VIRGINIA ELECTRIC AND POWER COMPANY
SURRY POWER STATION UNITS 1 AND 2
PROPOSED LICENSE AMENDMENT REQUEST
TECHNICAL SPECIFICATIONS SURVEILLANCE REQUIREMENT FOR GENERIC
LETTER 2008-01 (GAS ACCUMULATION)
RESPONSE TO REQUEST FOR ADDITIONAL INFORMATION

Response to NRC Request for Additional Information
Technical Specifications (TS) Surveillance Requirement
for Generic Letter 2008-01 (Gas Accumulation)

RESPONSE TO NRC REQUEST FOR ADDITIONAL INFORMATION
SURRY POWER STATION UNITS 1 AND 2

Figure 1
Surry Unit 1 Safety Injection System
(Unit 2 similar)

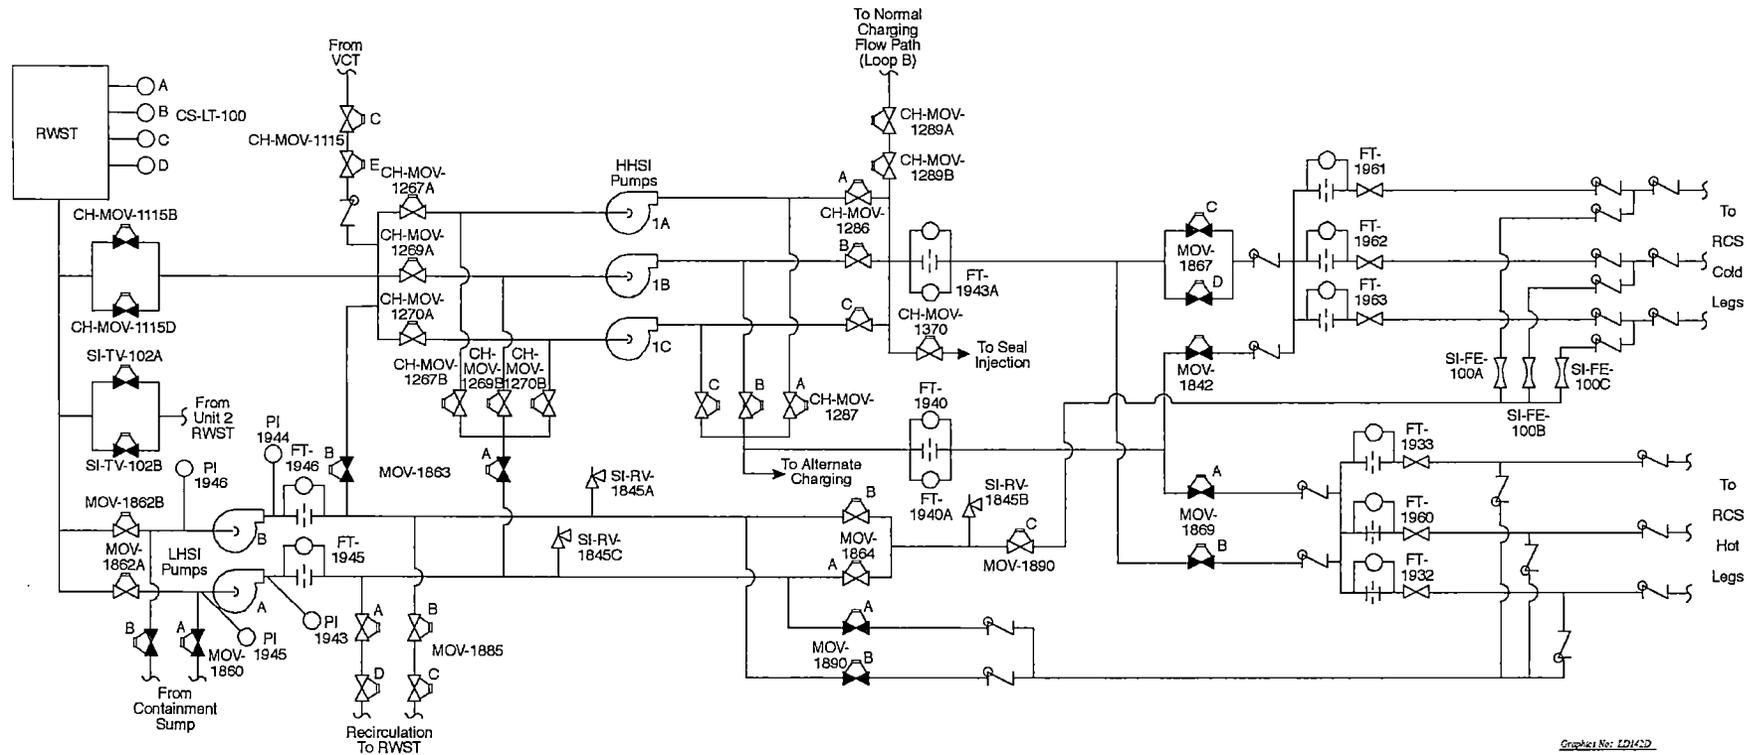
- b. *For each discovered void, the Mode, date, location, void quantity, void acceptance criterion, post void action (location restored to a water-solid condition?) and reason for discovery of the void (examples include routine surveillance, accumulator behavior, reactor coolant leakage). If the void quantity exceeded the void acceptance criterion, then provide the disposition with respect to the impact on operability.*

The instances where gas voids were discovered in the SI piping during the performance of the applicable surveillance procedures from January 2008 through July 2015 are discussed below. (Reference Figure 1.)

- January 2011 - Gas was discovered during quarterly performance of the venting surveillance procedure. Operations identified gas at vent valve 1-SI-435 after cycling 1-SI-MOV-1863B. A rotameter and stopwatch were used to estimate the size of the gas bubble. A total of 0.43 cubic feet of gas was vented through the rig with 1-SI-MOV-1863B in the closed position. A confirmatory UT was performed to verify the SI header downstream of

- June 2012 - Two voids were detected in the SI system piping during the quarterly performance of the surveillance procedure. The first void was detected at 1-SI-1047, the vent valve on line 8"-SI-14-153 LHSI discharge to HHSI suction upstream of 1-SI-MOV-1863B. The void volume was 0.0036 cubic feet. The acceptance criterion is 0.8 cubic feet.

- March 2013 - A void was discovered at 1-SI-179, downstream of 1-SI-MOV-1890, during the quarterly surveillance. The void size was calculated to be 0.1722 cubic feet, which was 21.5% of available margin of the acceptance criterion of 0.80 cubic feet. Based on this margin, the LHHSI system remained capable of performing its design function, despite the presence of the void. 1-SI-179 was successfully vented in accordance with station procedures, and as-left readings on the pipe indicated that it was water solid. Additionally, the quarterly surveillance was completed with no other voids identified.

- March 2013 – The void size identified during this surveillance is the only void that has exceeded an acceptance criterion since January 2008. On March 22, 2013, a 1.76 cubic feet void was found at 2-SI-179, downstream of 2-SI-MOV-2890C. At the time of void identification, the acceptance criterion was 0.80 cubic feet. This void size was listed as the acceptance criterion since it was believed that at a greater void size the relief valves would potentially lift on the LHSI pumps' discharge piping due to pressure spikes within the system. However, a Westinghouse analysis evaluated five cubic feet of air (at 100 psia) for impact on the Reactor Coolant System (RCS) during accident conditions and concluded this amount of gas would have no impact on the various accident analyses. Therefore, the identified void volume was bounded by the Westinghouse evaluation. In January 2013, the quarterly surveillance procedure was performed satisfactorily, which verified the relief valves do not lift on pump start, thus indicating the volume of air in the system was not sufficient to cause a pressure spike such that the relief valves would lift.
